**ADDENDUM NO. 1  
TO THE**

**GARDENDALE AND VILLAGE PARK WEST PRESSURE REDUCING STATION (PRS) REPLACEMENT PROJECT**

June 10, 2024

## **ADDENDUM NO. 1 DRAWING REVISIONS**

DRAWING  
C-2

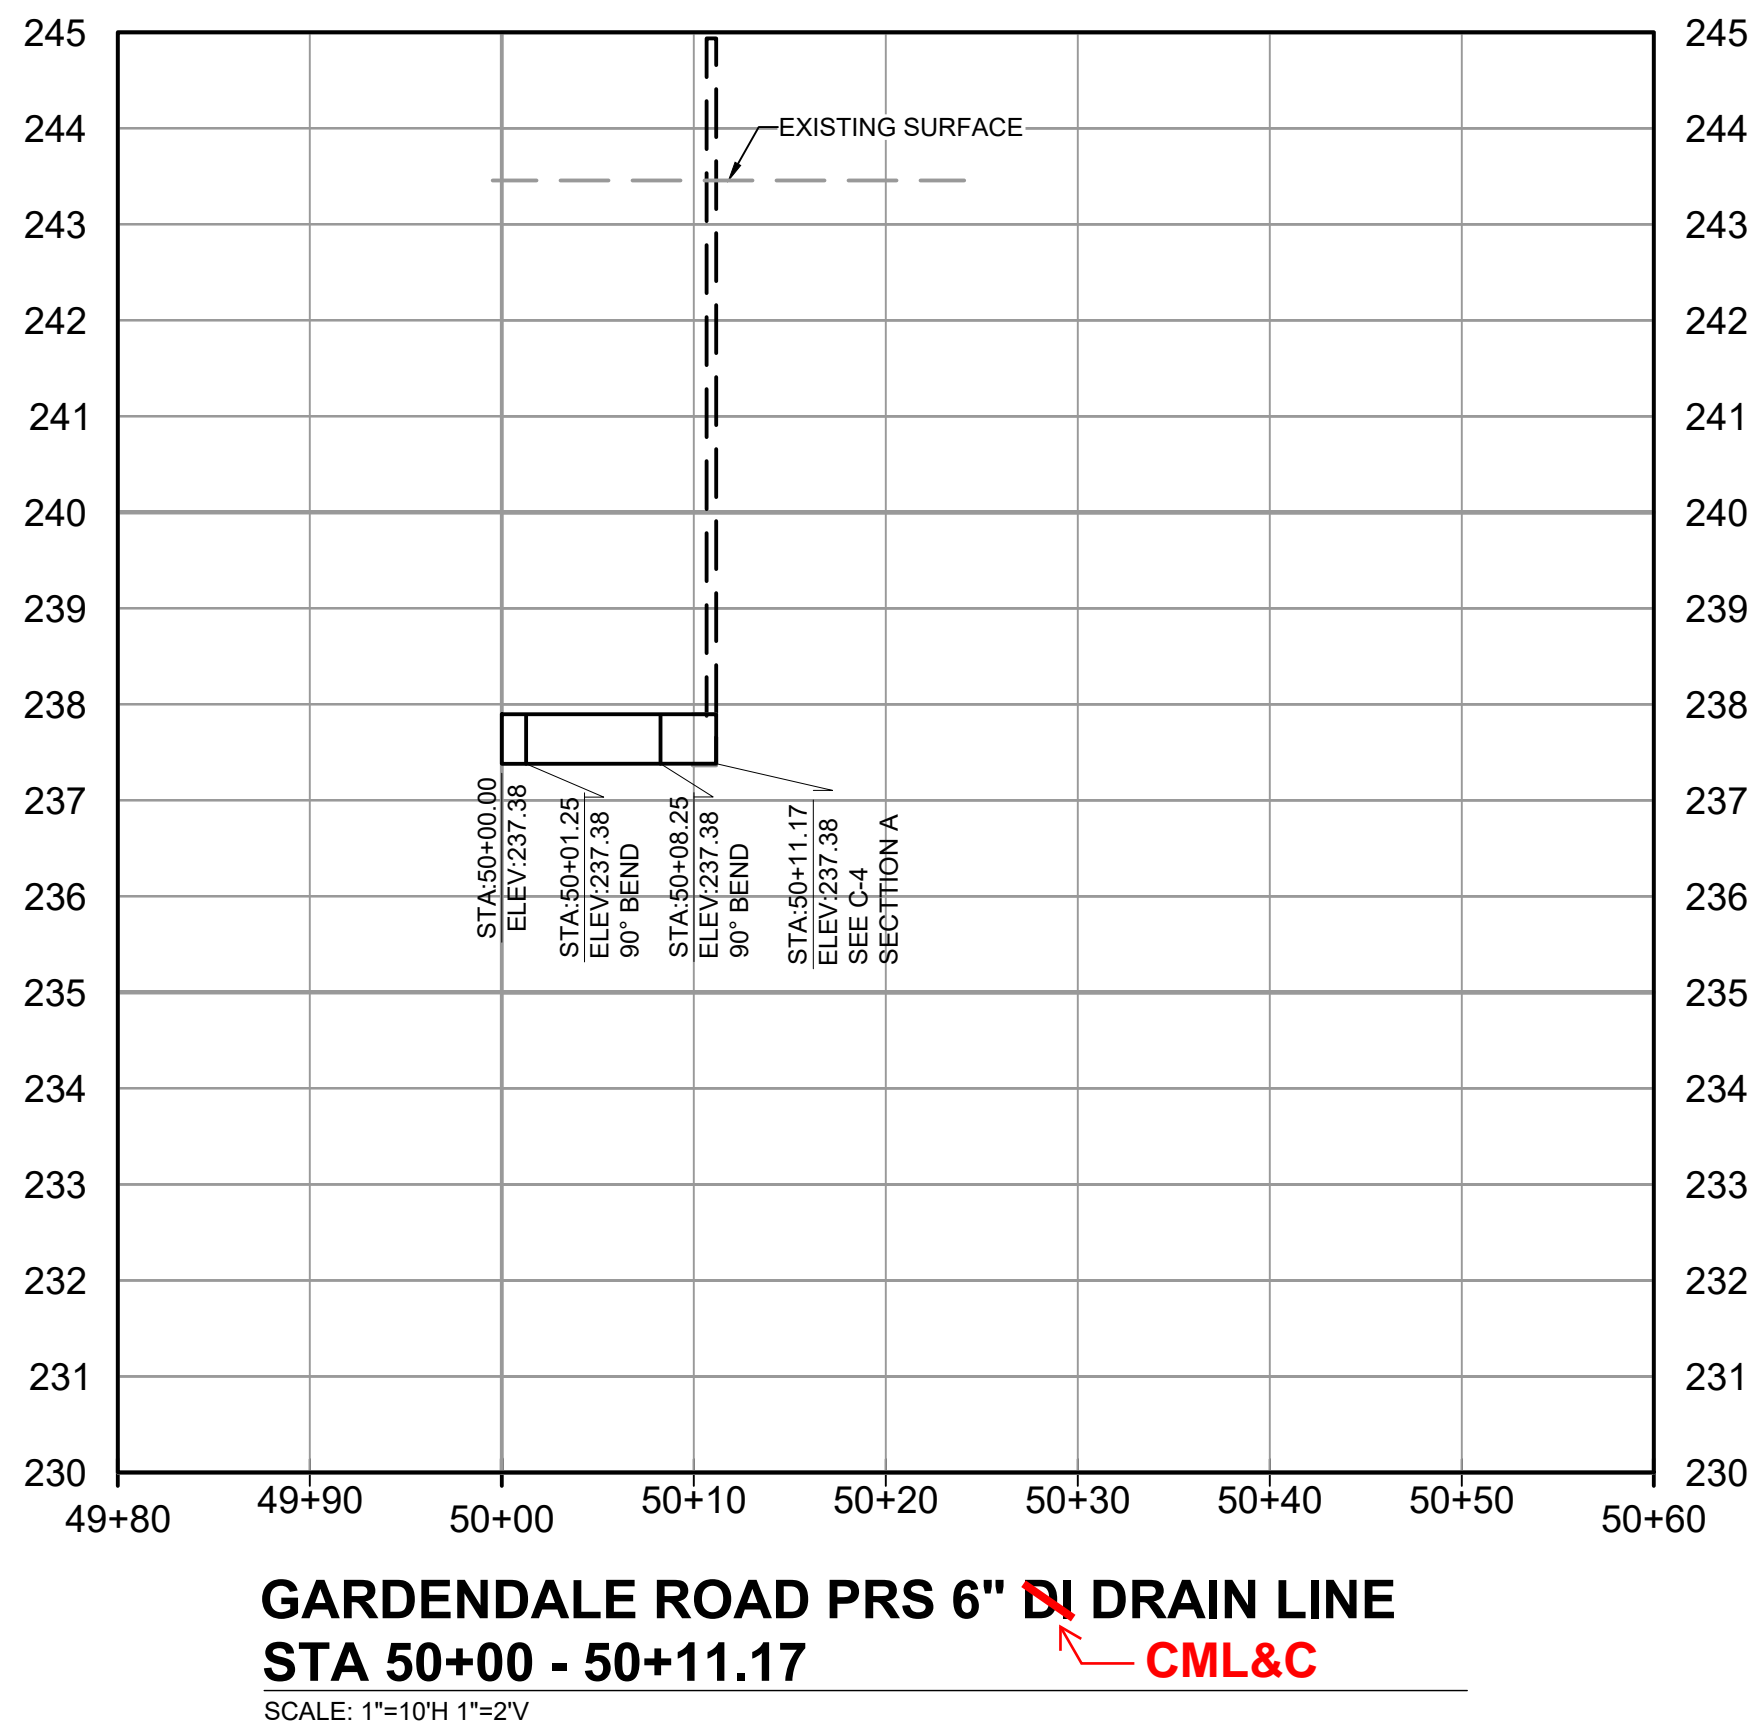
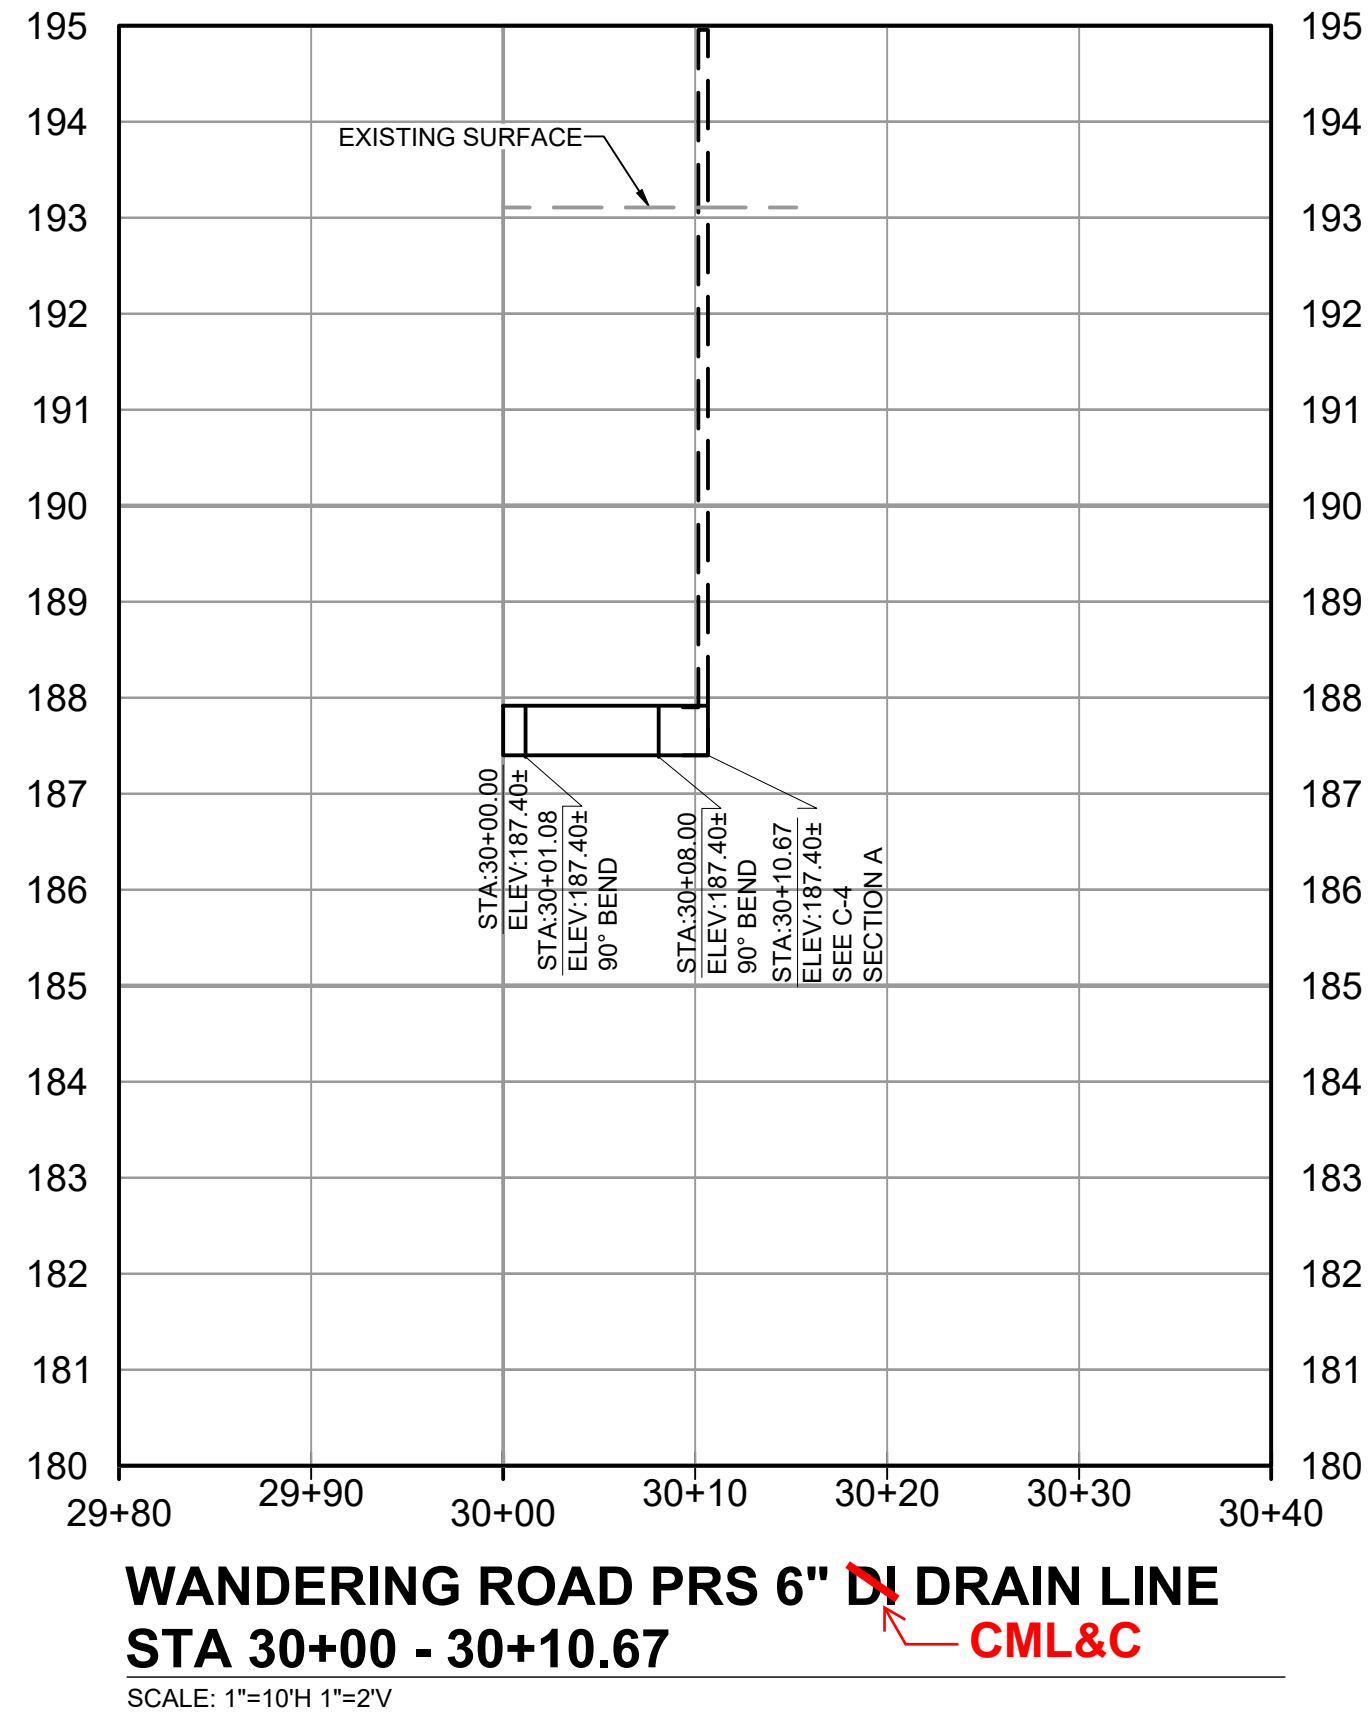
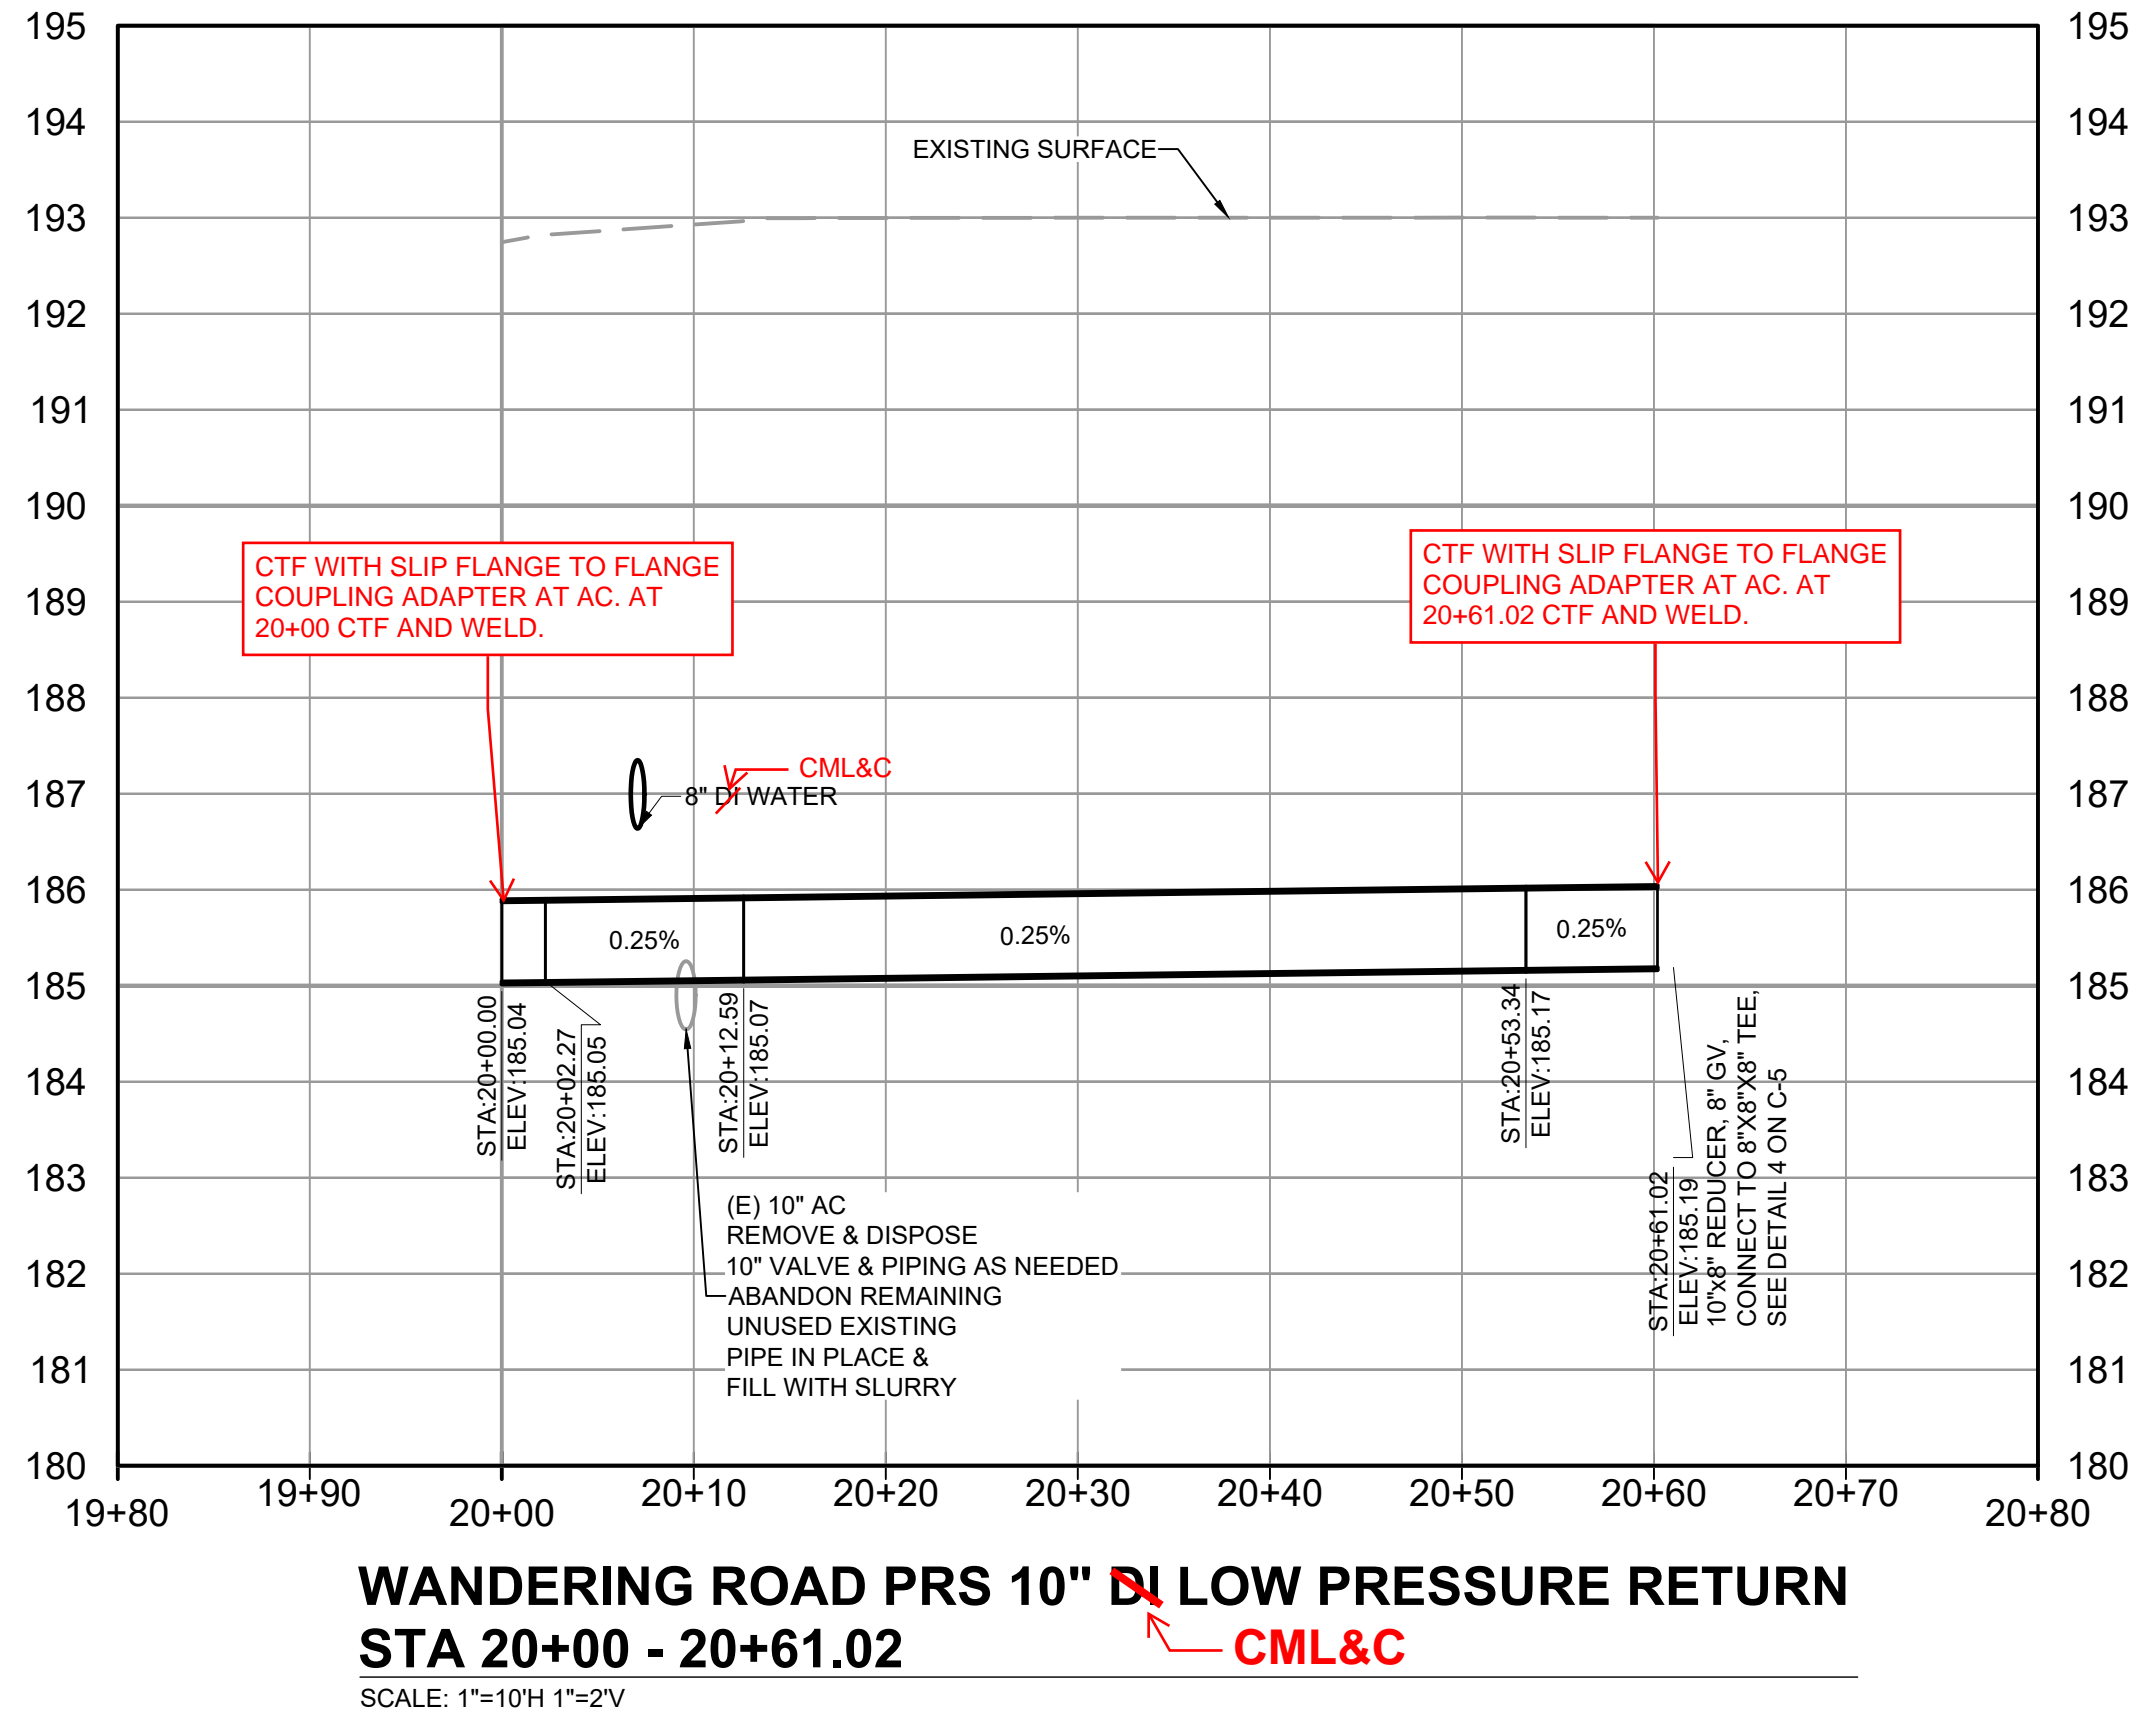
6. Q: What is the minimum offset the SDG&E relocation will be from existing pressure reducing station (PRS) that is called for demo on drawing C-2?  
**A: Contractor shall assume a minimum 5ft offset between the relocated gas line and existing PRS. Contractor shall field locate final alignment of the relocated gas line per C-2.**

1. Drawing G-2 General Notes; **REVISE** per attached Drawing
2. Drawing C-1 Village Park West PRS, Wandering Road 10" Waterline Improvements; **REVISE** per attached Drawing
3. Drawing C-2 Gardendale Road 14" Waterline Improvements; **REVISE** per attached Drawing
4. Drawing C-3 PRS Piping Profiles I; **REVISE** per attached Drawing
5. Drawing C-4 Curb Outlet Sections; **REVISE** per attached Drawing
6. Drawing C-5 PRS Piping Detail I; **REVISE** per attached Drawing
7. Drawing C-6 PRS Piping Detail II; **REVISE** per attached Drawing
